Record of Decision
Liberty Industrial Finishing Site
Town of Islip, Suffolk County
Site Number 1-52-108

DECLARATION STATEMENT - RECORD OF DECISION

**Liberty Industrial Finishing Site
Proposed Remedial Action Plan
Town of Islip, Suffolk County
Site No. 1-52-108**

**GROUNDWATER CONTAMINATION CONTOURS
 SAMPLE RESULTS FOR CHROMIUM**

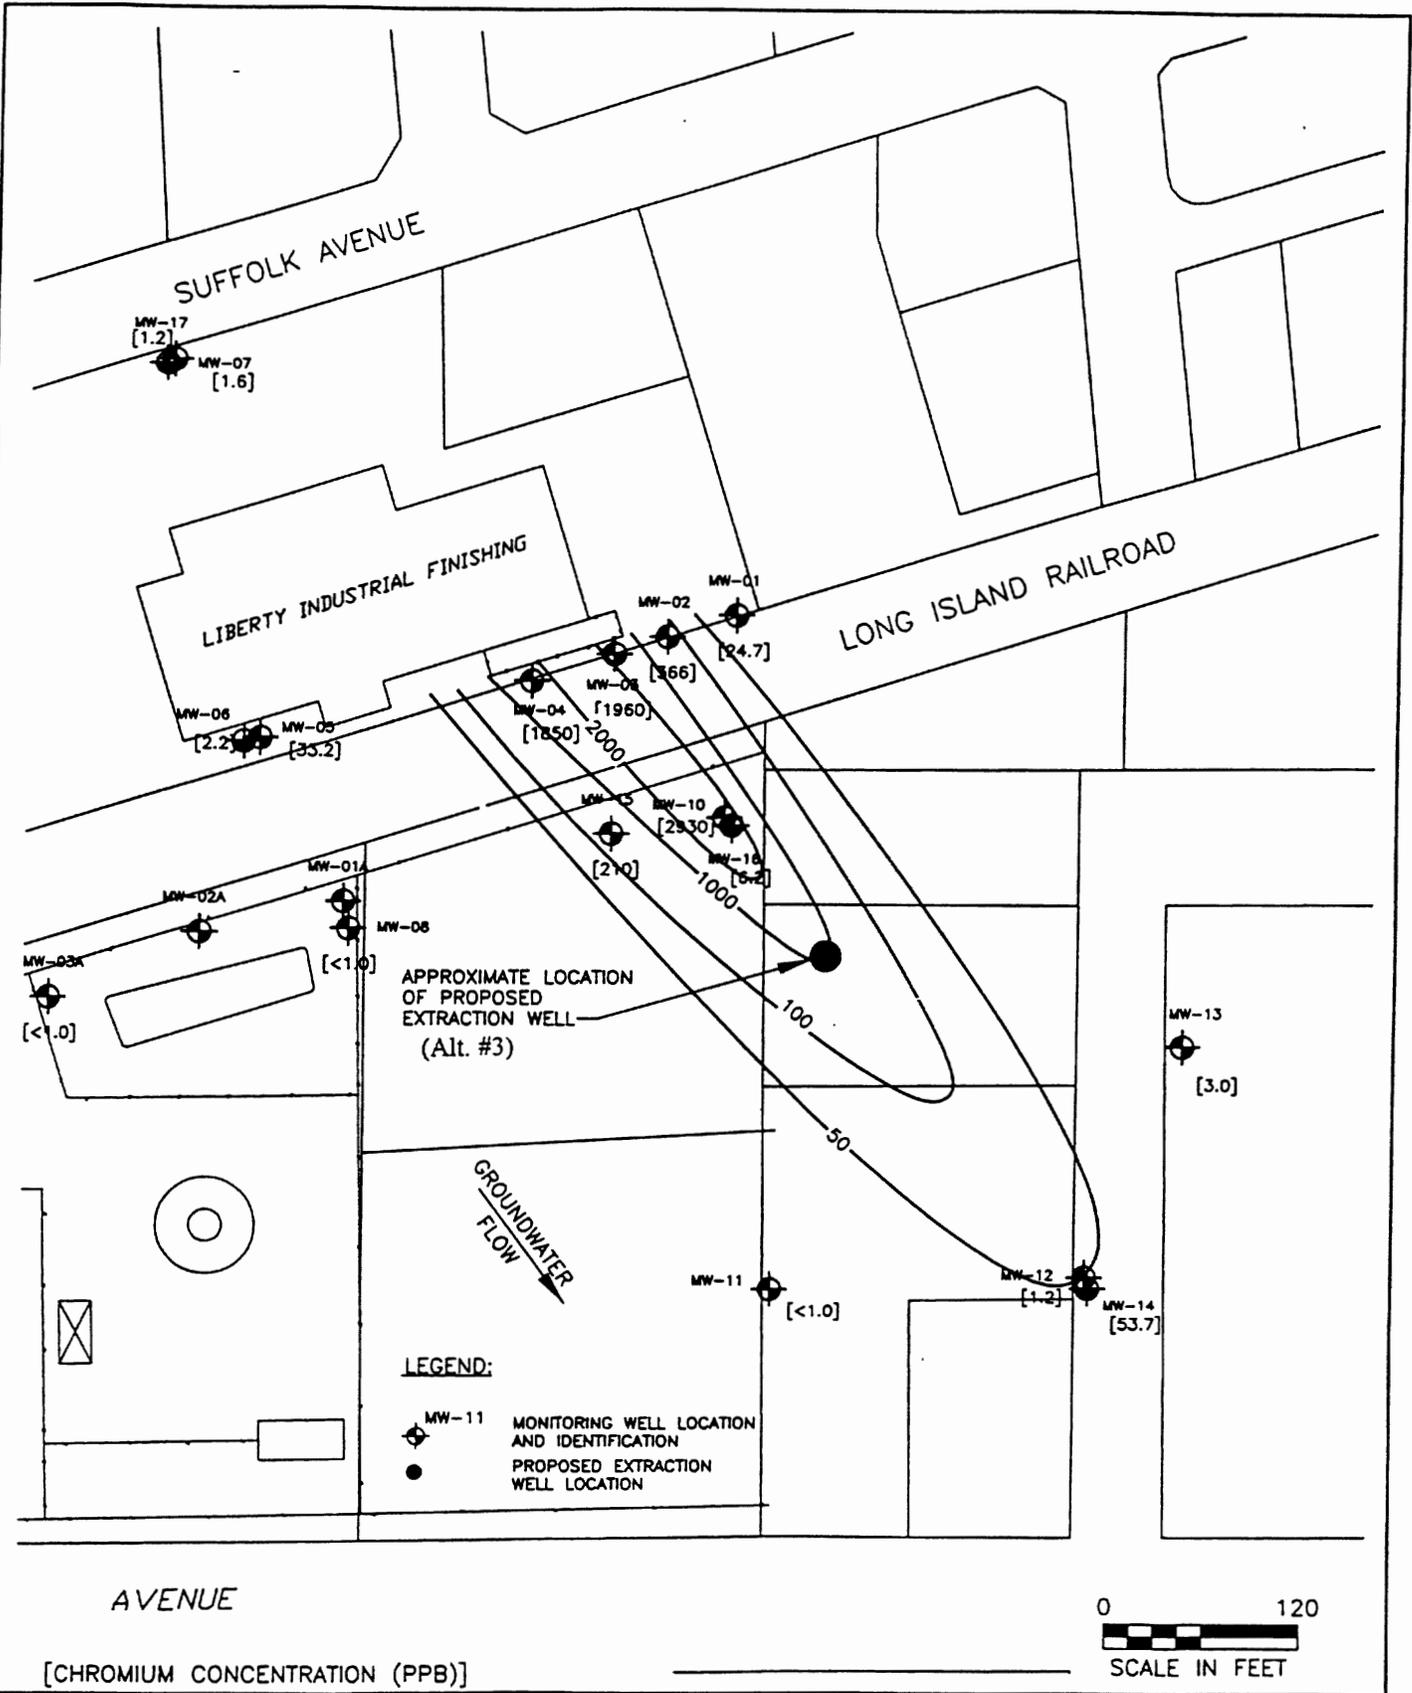
The need for extraction at proposed or other sites and levels cannot be ruled out at this point. Note that the site for the proposed extraction well on Figure 8 is not on the ball field as stated on page 16 of the PRAP, but on the American Legion property.
